**MASTER DEVELOPMENT DRAINAGE PLAN  
AMENDMENT  
FOR  
FOREST LAKES (FOREST LAKES PHASE 2)  
EL PASO COUNTY, COLORADO**

**December 2017**

With the application being a PUDSP (combined PUD & Preliminary Plan), this drainage report title and content should be a combined amendment to the MDDP and Preliminary Drainage Report For Forest Lakes Ph 2.

Add "PCD File No. PUDSP181"

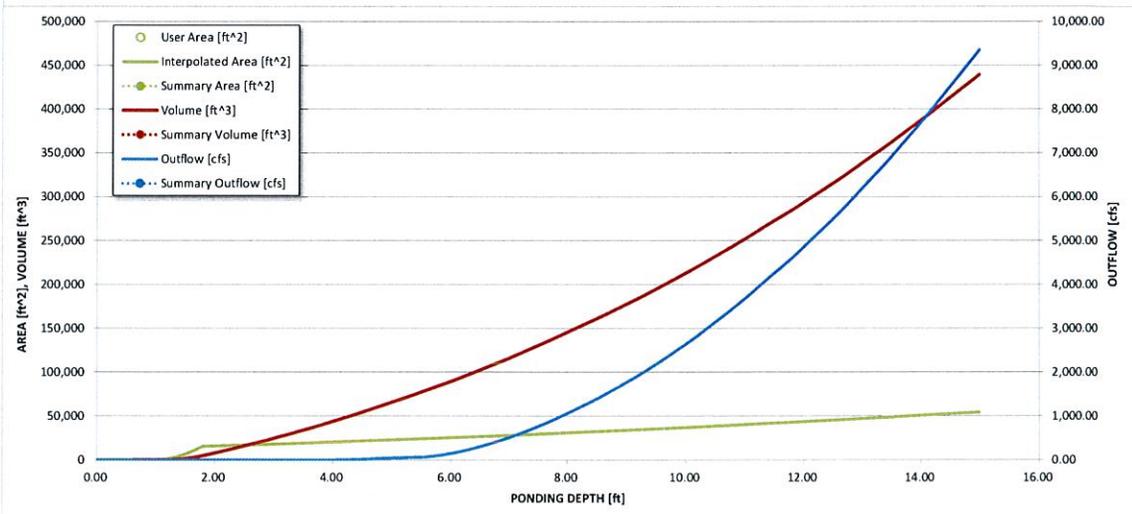
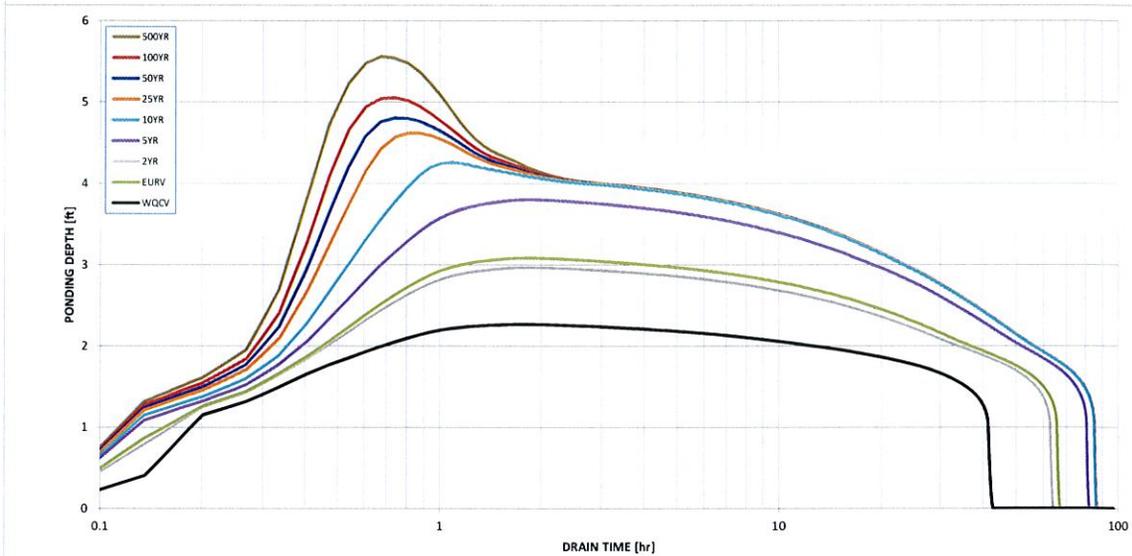
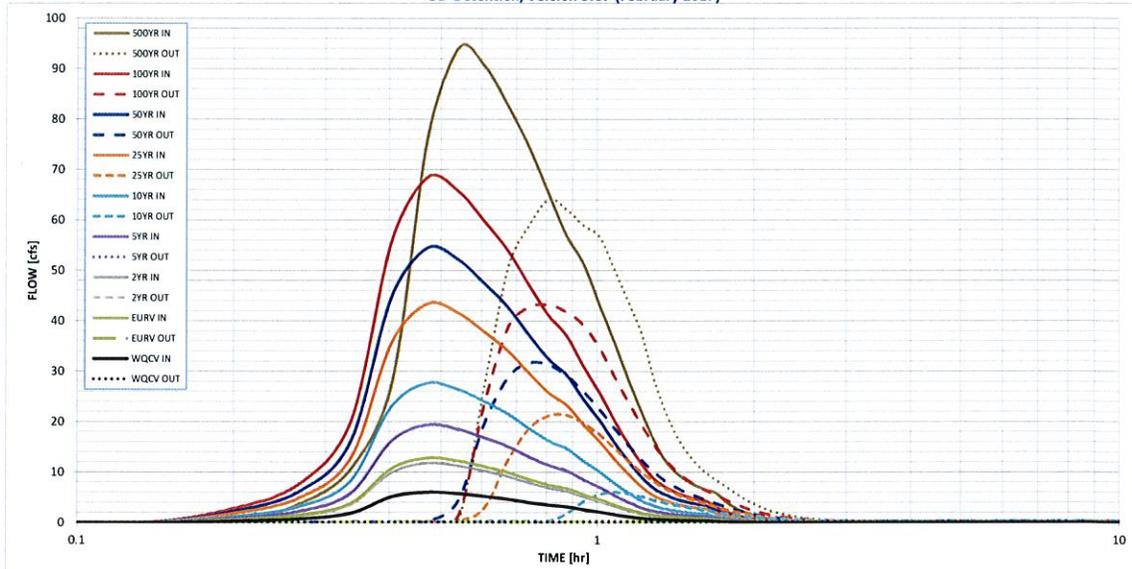
Per UDFCD "The maximum allowable 100-yr release rate for a full spectrum detention facility is equal to 90 percent of the predevelopment discharge for the upstream watershed." (Ch 12, Section 4.1.2) Comment applies to all proposed ponds.

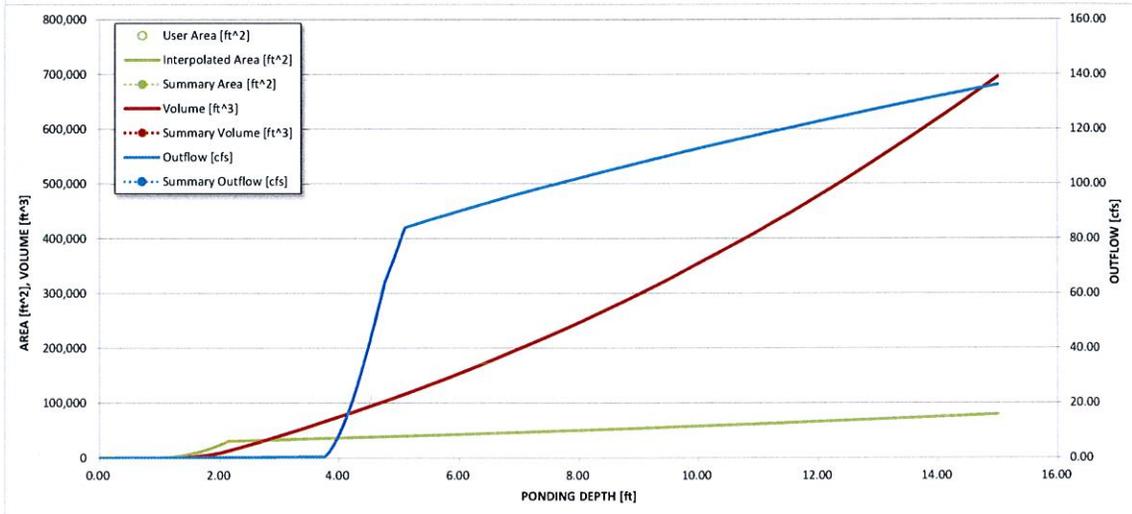
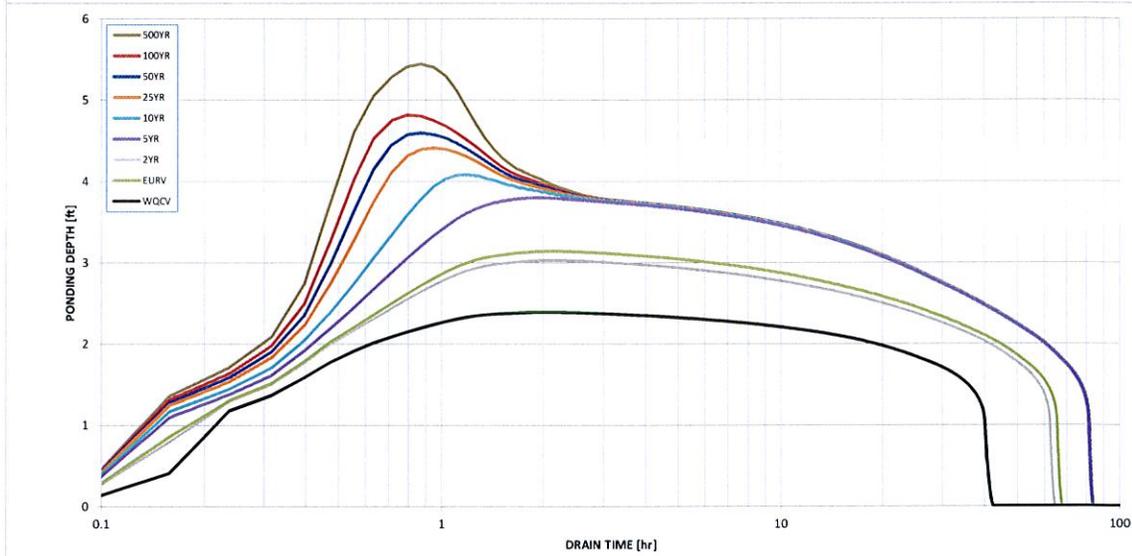
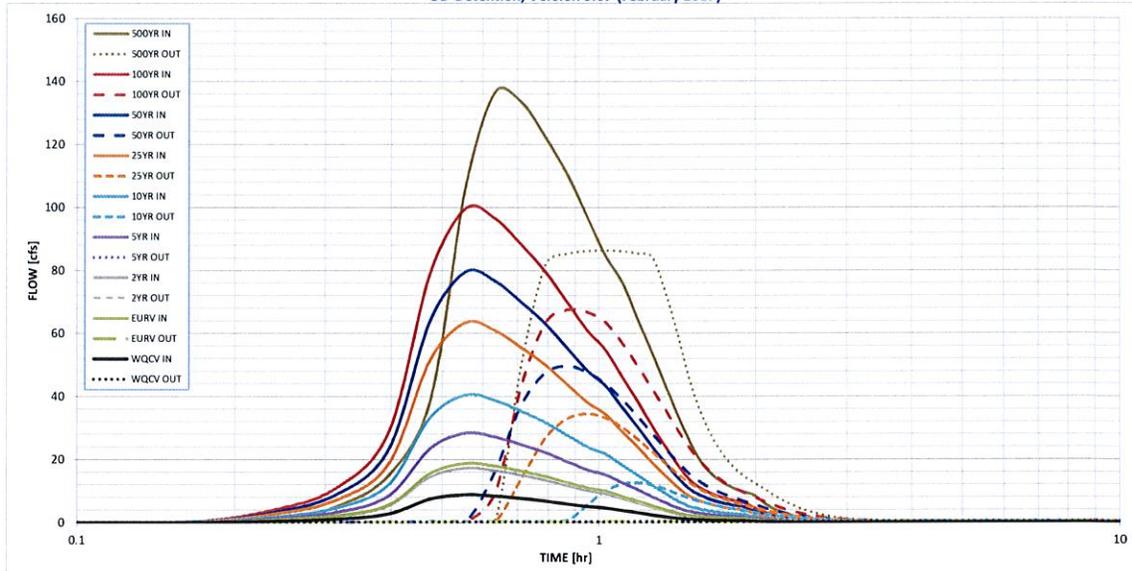
Provide emergency spillway

**POND A**  
 1,522 AC-FT EURV  
 23,806 SF NEEDED AT 100 YR  
 WSE @ 7' DEPTH + 3.0'  
 MICROPOOL  
 22.89 TRIBUTARY ACRES  
 Q100 INF = 68.4 CFS  
 Q100 OUT = 43.2 CFS

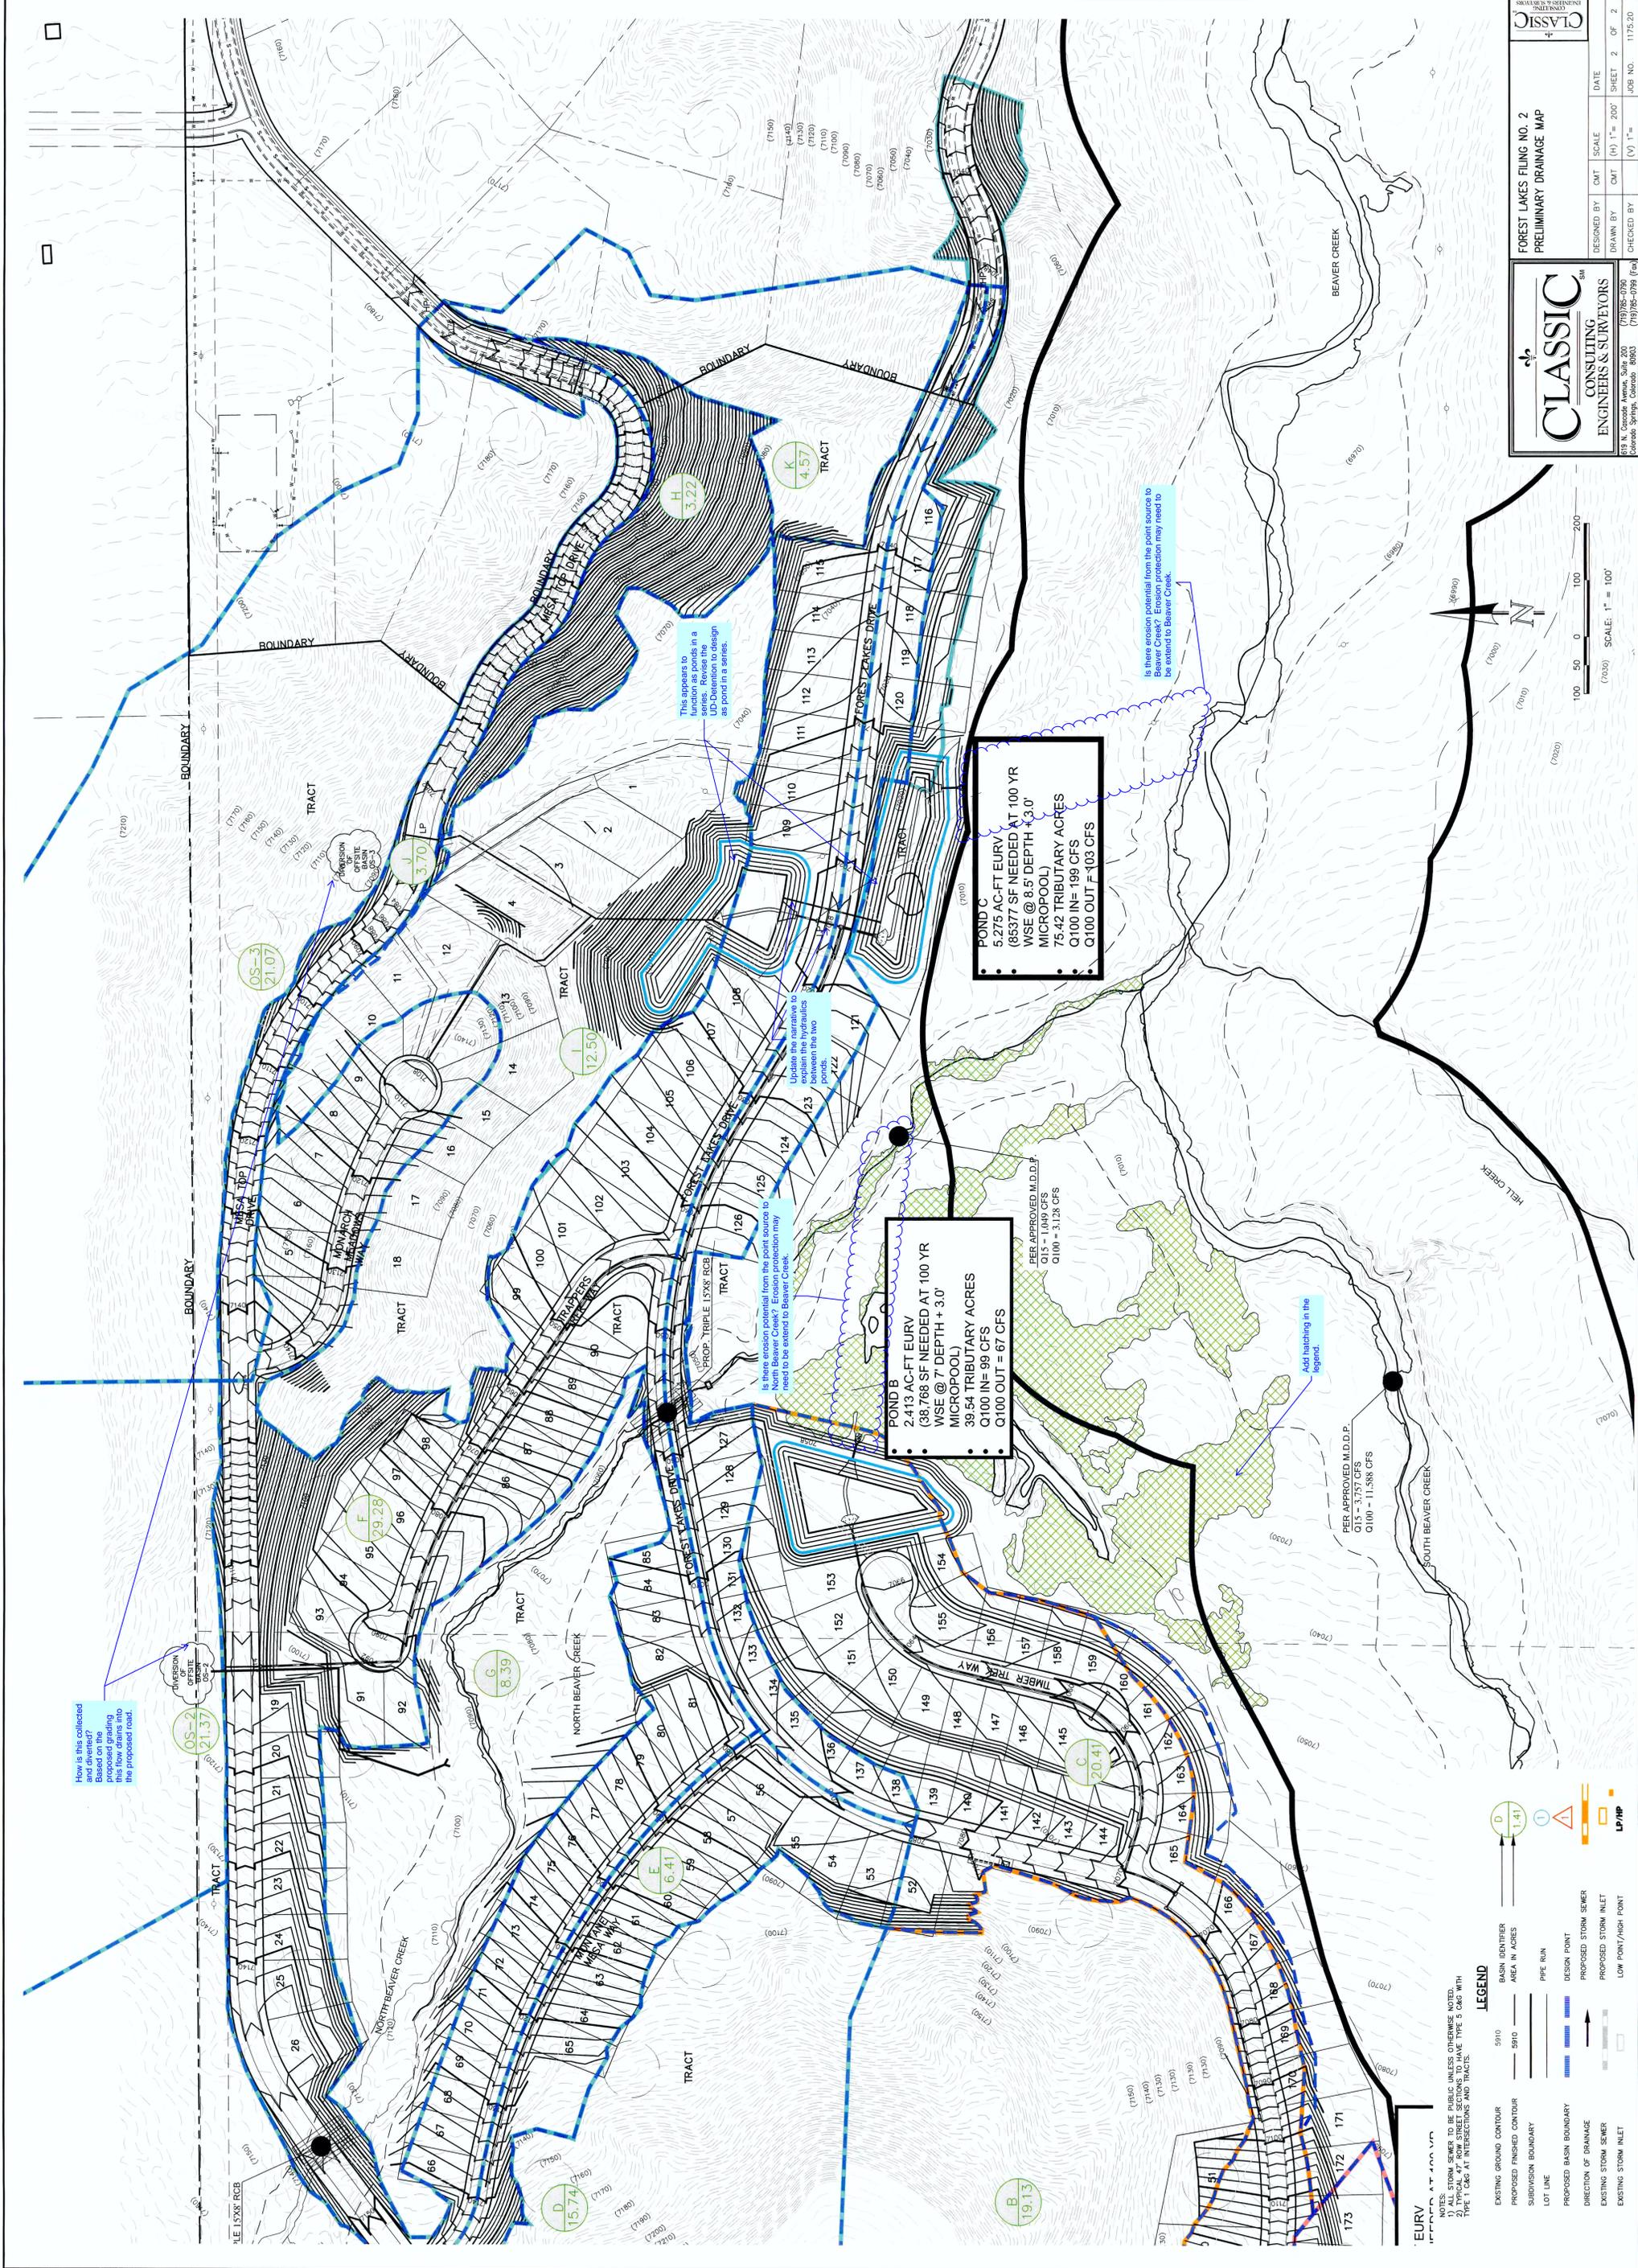
Is there erosion potential from this point source to South Beaver Creek? Erosion protection may need to be extended to Beaver Creek.

Low point of diversion. Where does this go?

Show how the OS-1 diversion continues to South Beaver Creek.
